**Response to Comments on the
Soil RCRA Facility Investigation/Remedial Investigation Work Plan, Pacific Gas and Electric Company (PG&E) Topock Compressor Station, Needles, California, Issued May 2011**
From
Combined United States Department of the Interior (DOI), California Department of Toxic Substances Control (DTSC), Fort Mojave Indian Tribe (FMIT) and Hualapai Comments

Response to Comments on the
Soil RCRA Facility Investigation/Remedial Investigation Work Plan, Pacific Gas and Electric Company (PG&E) Topock Compressor Station, Needles, California, Issued May 2011
From
Combined United States Department of the Interior (DOI), California Department of Toxic Substances Control (DTSC), Fort Mojave Indian Tribe (FMIT) and Hualapai Comments

**FIGURE J-1
STAGING AREAS**
DISPLACED SOIL AND HAZARDOUS WASTE
MANAGEMENT PROCEDURES
PACIFIC GAS AND ELECTRIC,
TOPOCK COMPRESSOR STATION,
NEEDLES, CALIFORNIA

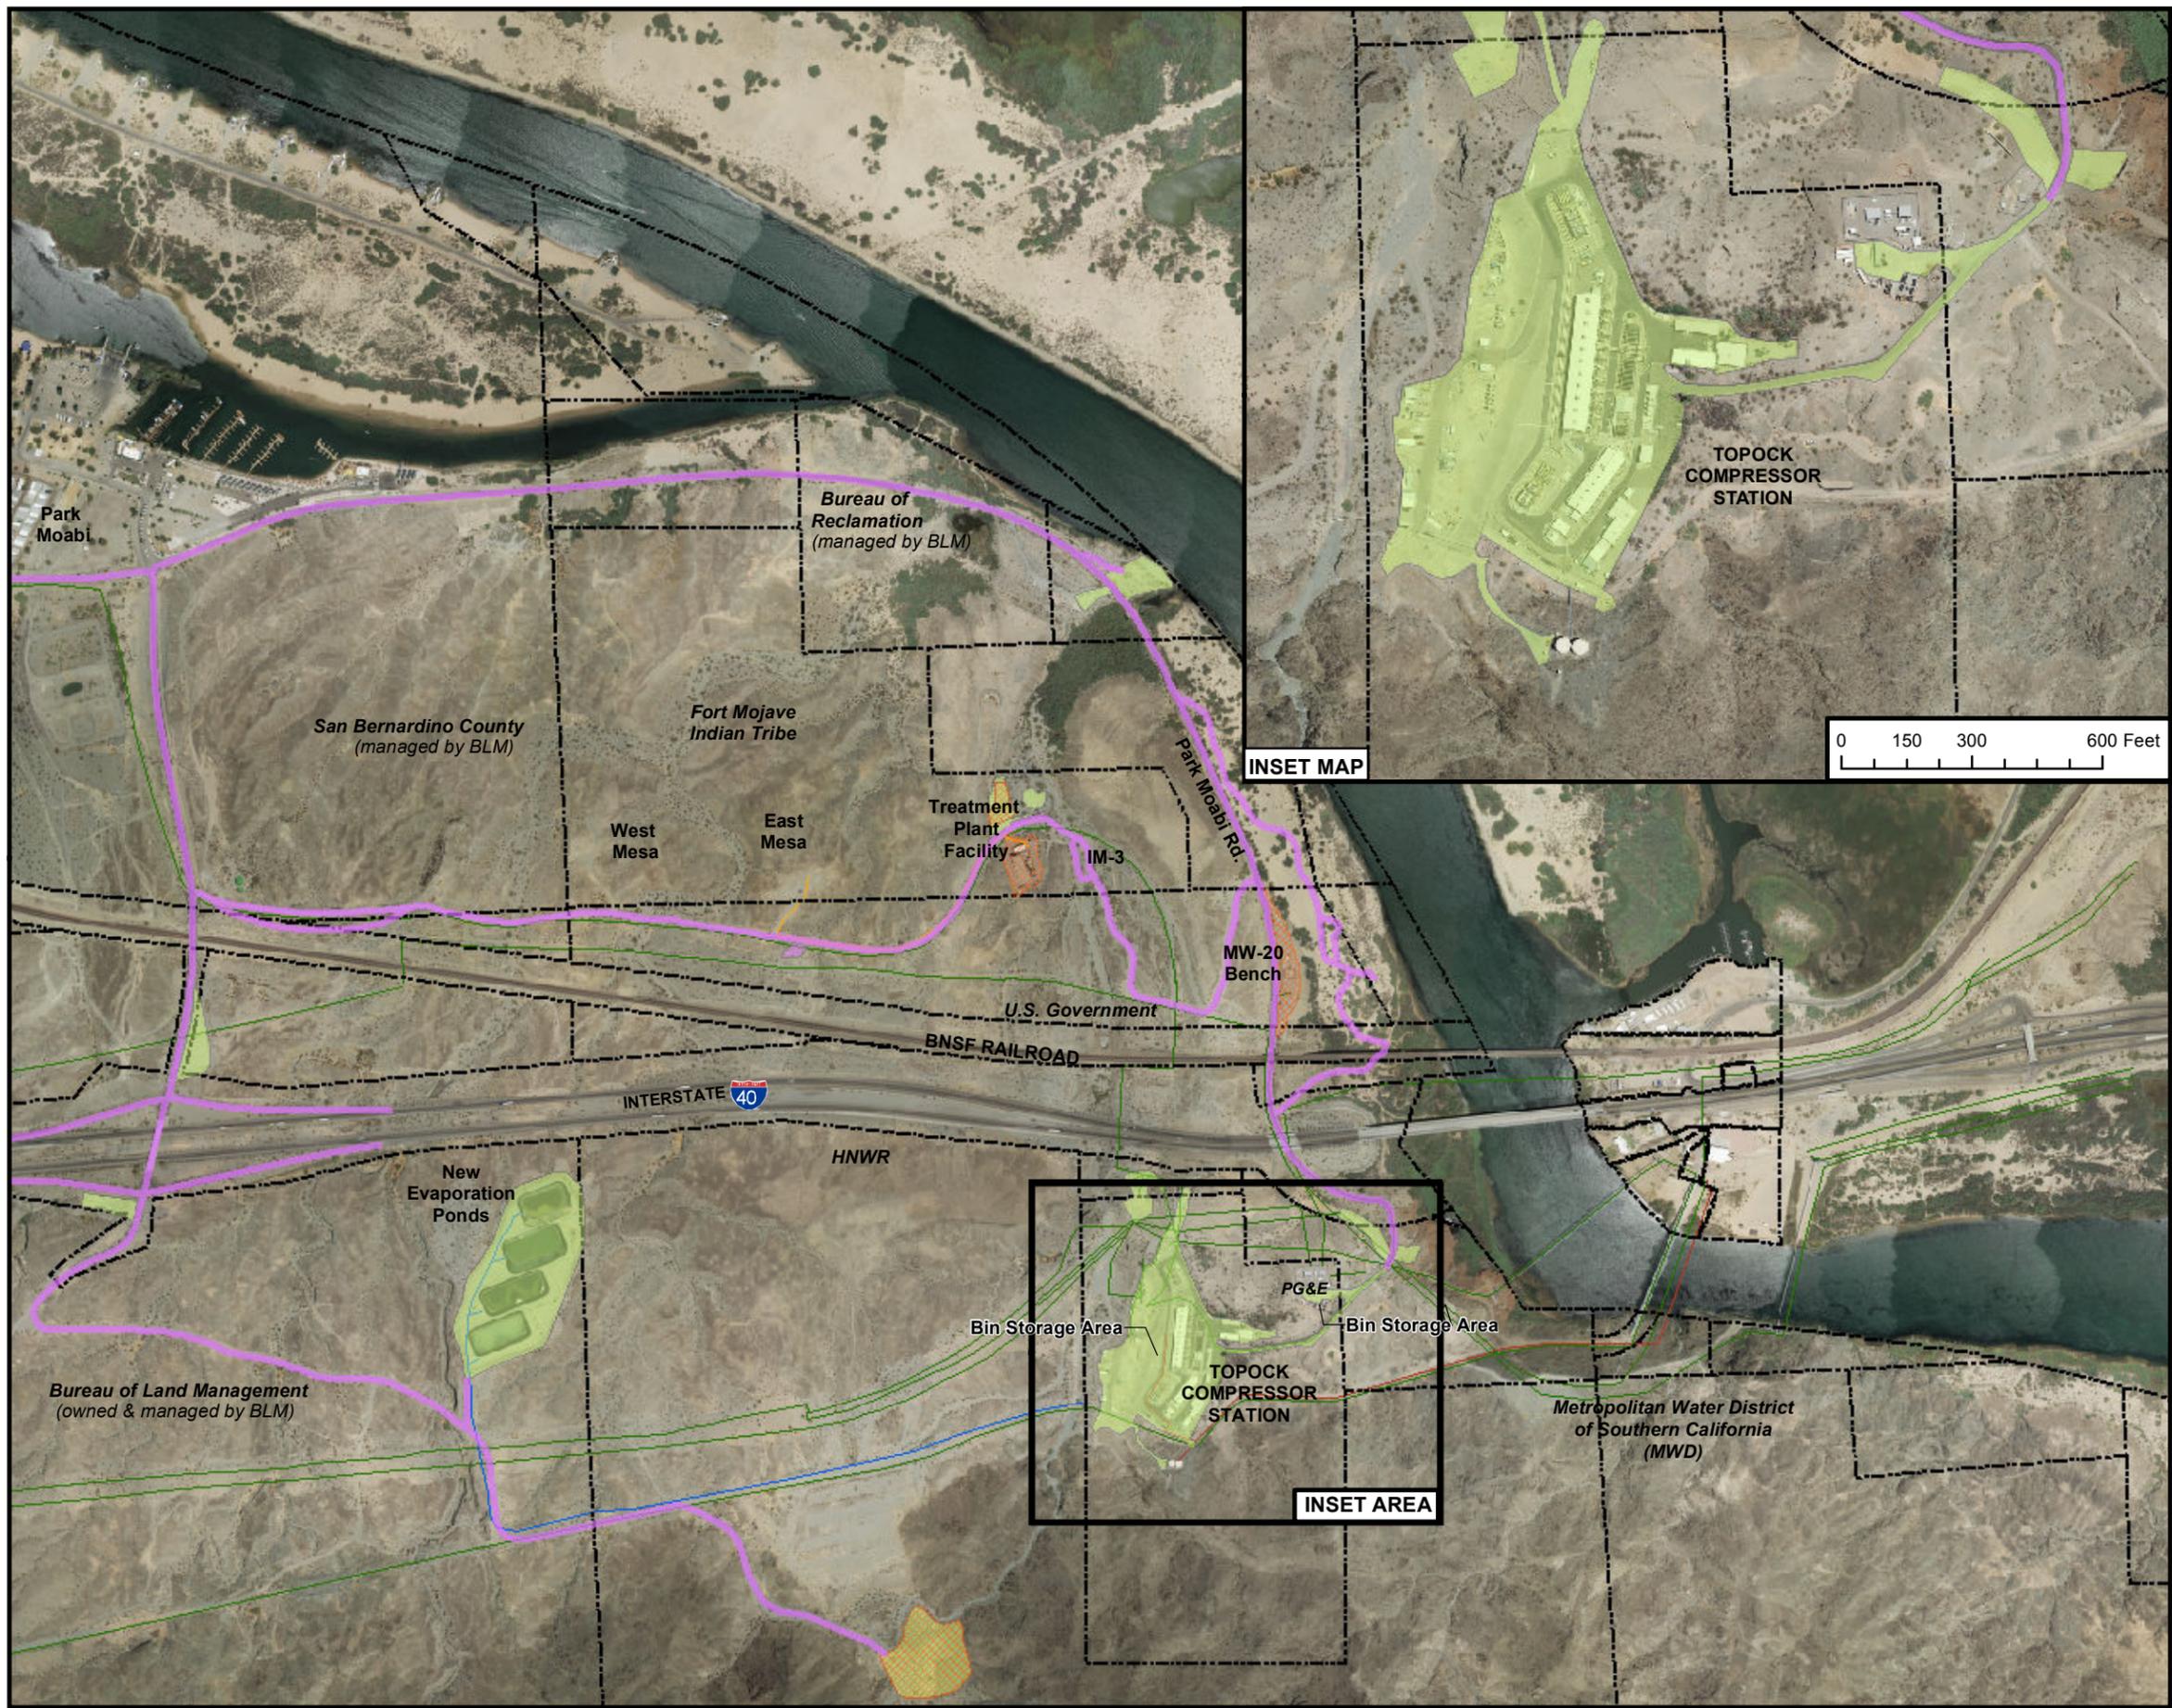
Clean soil that was removed during potholes/trenches or excavations will be reused as backfill into the same pothole/trench or excavation area, if practicable. Clean soil that was removed from boreholes cannot be used to backfill the borehole. Clean soil that cannot be immediately used as backfill may be reused in other areas within the Area of Potential Effect (APE) or left in the drums or rolloff bins for future reuse within the APE. Storage area(s) for clean soil may include all staging areas shown on Figure J-1.

compressor station fence line. The staging areas shown on Figure J-1 include the identified long-term storage areas.
